**CORRESPONDENCE COVER SHEET
WASTE PERMITS DIVISION
TEXAS COMMISSION ON ENVIRONMENTAL QUALITY**

Facility Name: City of Victoria Landfill

Re: Response to Second Technical Notice of Deficiency (TCEQ Tracking No. 27435345)
City of Victoria Landfill (Type I)
Victoria, Victoria County, Texas
CN600243257/RN100212968
Proposed TCEQ Permit Number MSW-1522B
Major Amendment Permit Application

project	107608	contract	-
drawing	I/II.B.5	rev.	2
sheet	13	of 25	sheets
file	107608III.A1.12.dwg

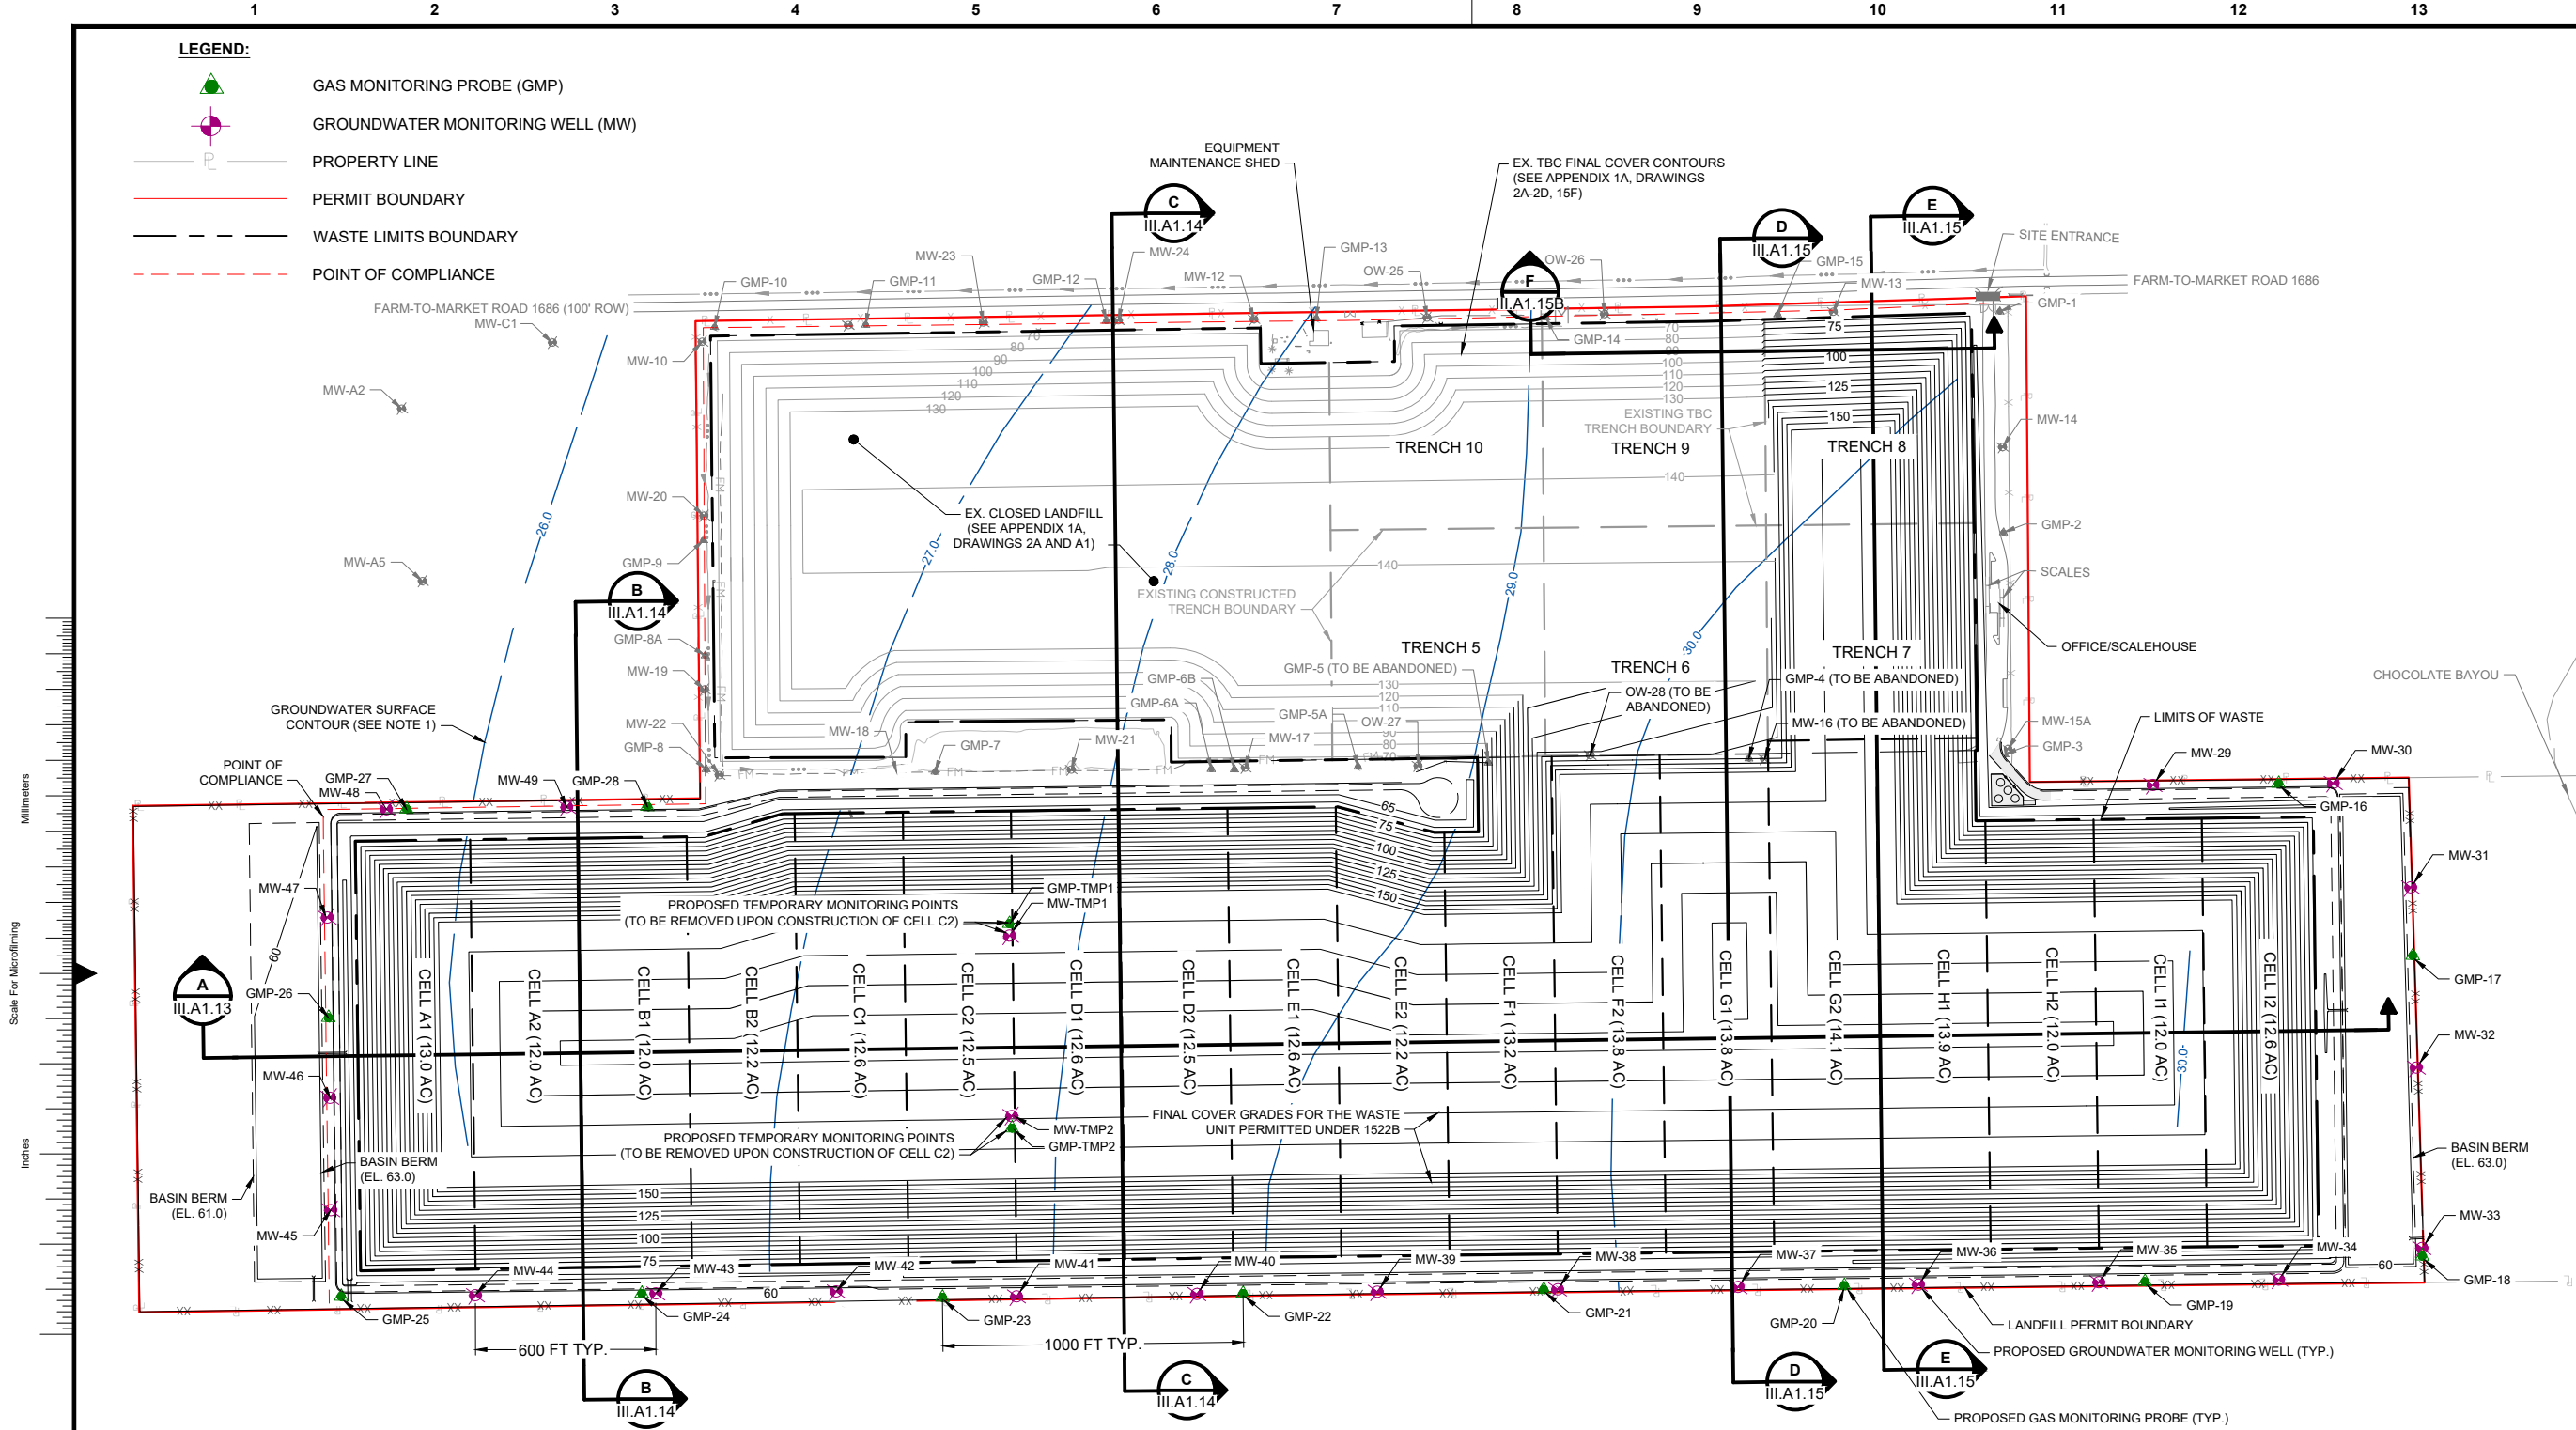
<i>b. To address Comment T3.a above, revise Drawing III.A1.12 to identify an additional cross-section for the north portion of the landfill. The new cross-section needs to run the same direction as the existing Cross-section A.</i>	An additional cross section was added to Attachment III-1, Drawing III.A1.15B (new drawing) showing an east-west cut through Trench 9-10 sumps. The alignment of this new cross section is shown in the Base Grading Plans, Final Grading Plans and Environmental Monitoring Plan.
	<i>c. Revise Section 2.3 to describe the final covers installed in areas listed in Table I/II-1.</i>	Section 2.3.4 of Part I/II has been added to describe the components of the final covers installed in the areas listed in Table I/II-1.
	<i>d. Revise Table I/II-1 to note the type of liner and the type of final cover installed, or to be installed, in each area.</i>	Table I/II-1 has been revised to include footnotes that reference the relevant sections of Part I/II that discuss the liner system (Section 2.3.2 of Part I/II) and the final cover system (Section 2.3.4 of Part I/II) in each area. Section 2.3.4 of Part I/II also references the appropriate historic drawings that contain final cover details.

project	107608	contract	-
drawing	III.A1.3	rev.	2
sheet	4	of	25
file	107608III.A1.3.dwg	sheets

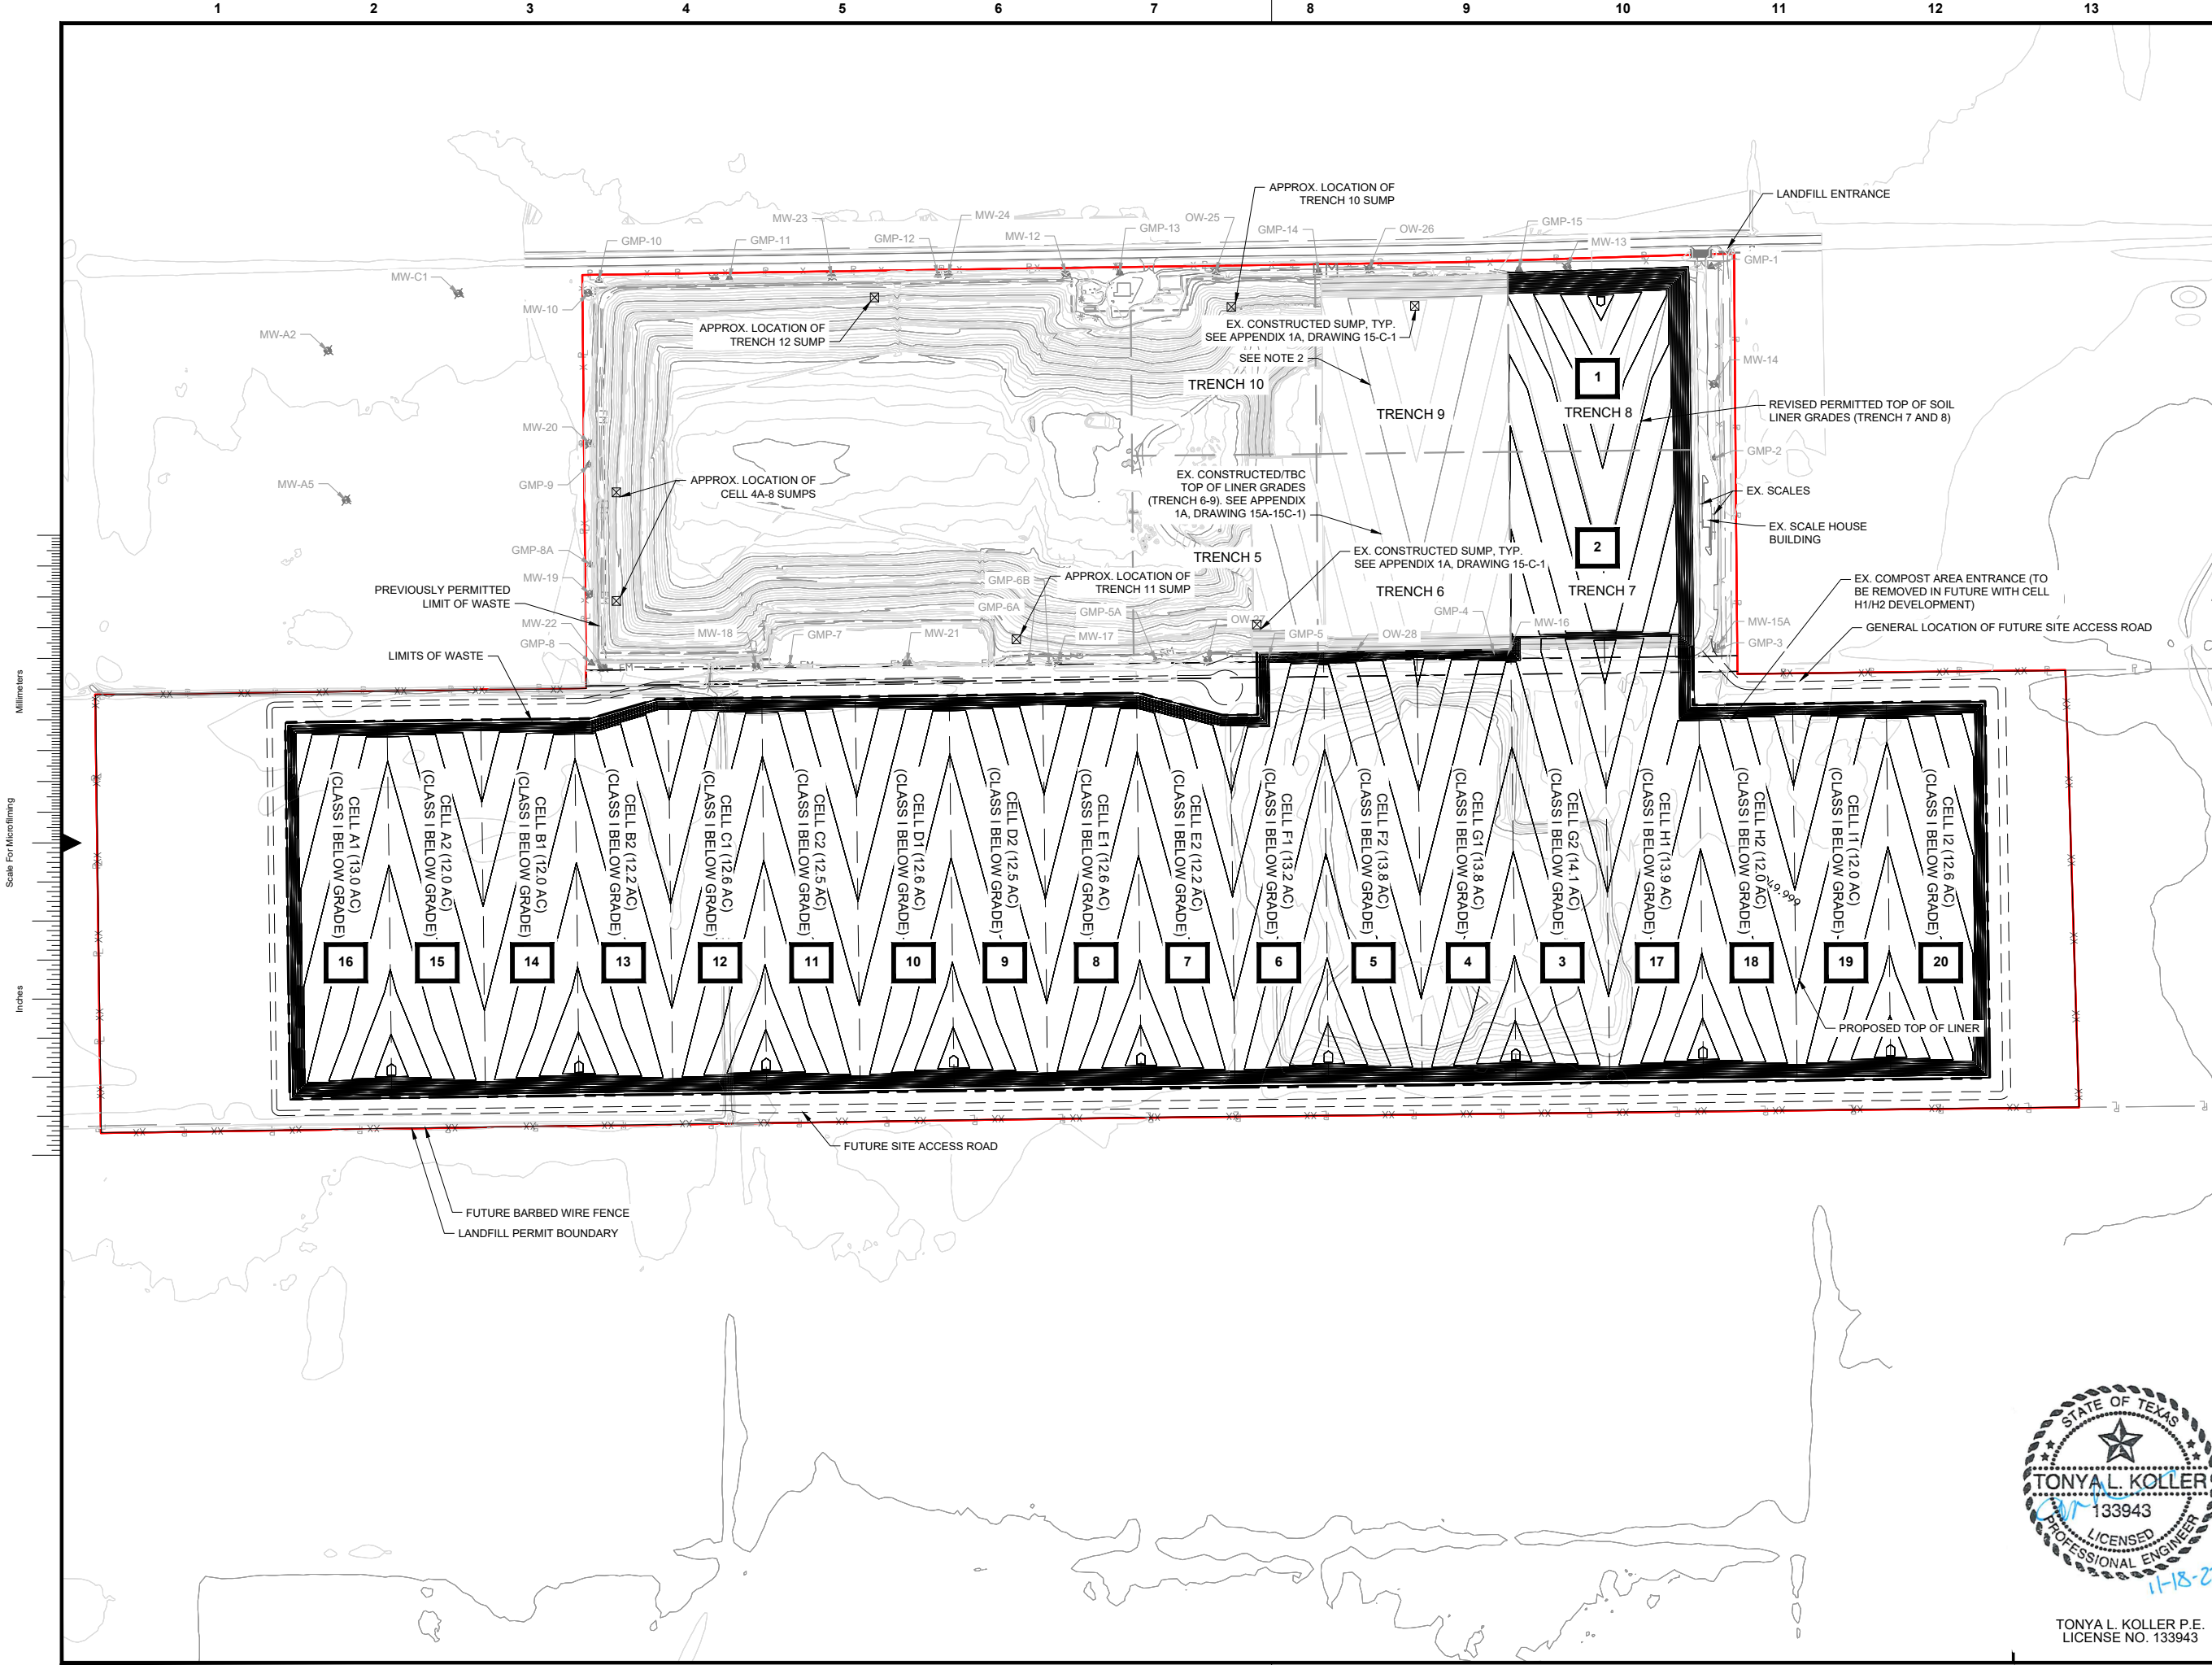
<i>d. Revise Drawing III.A1.3 and other relevant drawings to specify that all cells in the lateral expansion are designated as a cell in which the Class 1 waste will be disposed of in below grade area with a note about changing this designation through a permit modification prior to the cell development (refer to Comment T4.c. above).</i>	The Class 1 designation for each cell was provided on Attachment III-1, Drawing III.A1.4 in the previous submittal. A note has been added to Drawing III.A1.3 to reference that location, where the T4(d) revisions were made. The Class 1 designation has been revised to remove "OPTION FOR" and note 1 has been revised.
T5	<i>a. Revise the relevant portions in the application to specify that the material properties (internal and interface) used in the slope stability analysis will be tested on the materials to be used in the landfill development (including waste and construction materials); and the professional engineers responsible for the design and construction of the individual area will review the test results and decide whether the stability analysis results are still valid or new stability analysis using the test results is needed. The relevant portions of the application include, but not limited to, Attachments 4, 5, 7, 9, and 10 of Part III.</i>	Relevant sections of the application have been revised to specify that the material properties (internal and interface) used in the slope stability analysis will be tested on the materials to be used in Landfill development and results will be reviewed to decide whether the stability analysis results are still valid. The professional engineers responsible for the design and construction of the individual area will review the test results and decide whether the stability analysis results are still valid or new stability analysis using the test results is needed.
